Memorandum

To: Expert Consenting Panel - Ashbourne
From: Dean Morris (Maven Waikato Limited)
Subject: Ashbourne, Matamata –Maven Technical Response Memorandum
Date: 18th November 2025

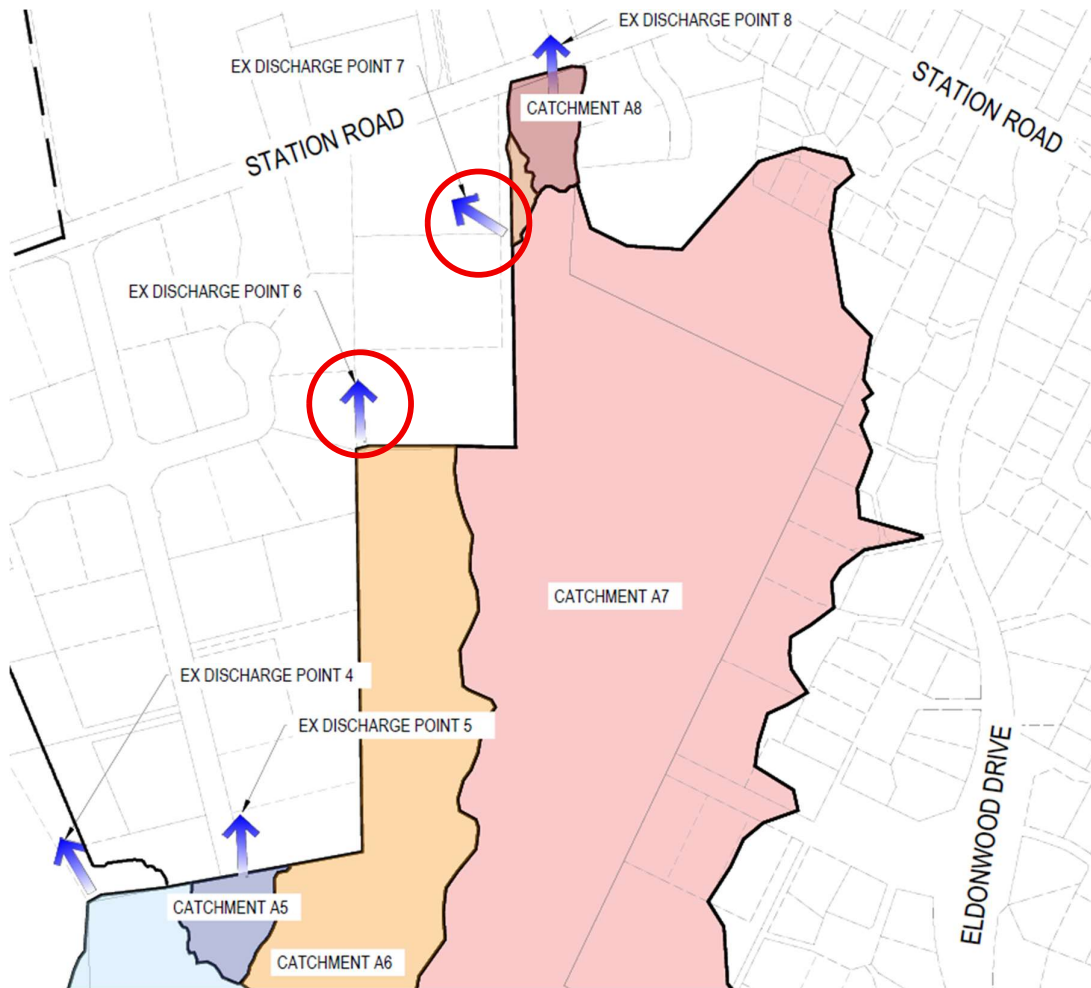
The proposed Greenway intercepts a large part of the catchment that otherwise flows through Highgrove and Station Rd. It bypasses these areas by diverting the flows directly to the eventual receiving environment the Waitoa stream while providing additional storage to replace what would otherwise be stored in the Highbrook and Station Rd drains.

Soakage and dry pond storage, while not proposed everywhere with the high-water table in the lower lying areas of the north, some are still proposed where suitable vertical clearance is available.

Detention Tanks are proposed to dwellings within the northern catchment where soakage vertical clearance is not achievable.

The proposed wetlands to the retirement village and northern residential catchments include detention for events upto the 100yr event with slow release below predevelopment levels.

The result is a significant reduction in peak flows of stormwater runoff to Highgrove and Station Rd as follows:
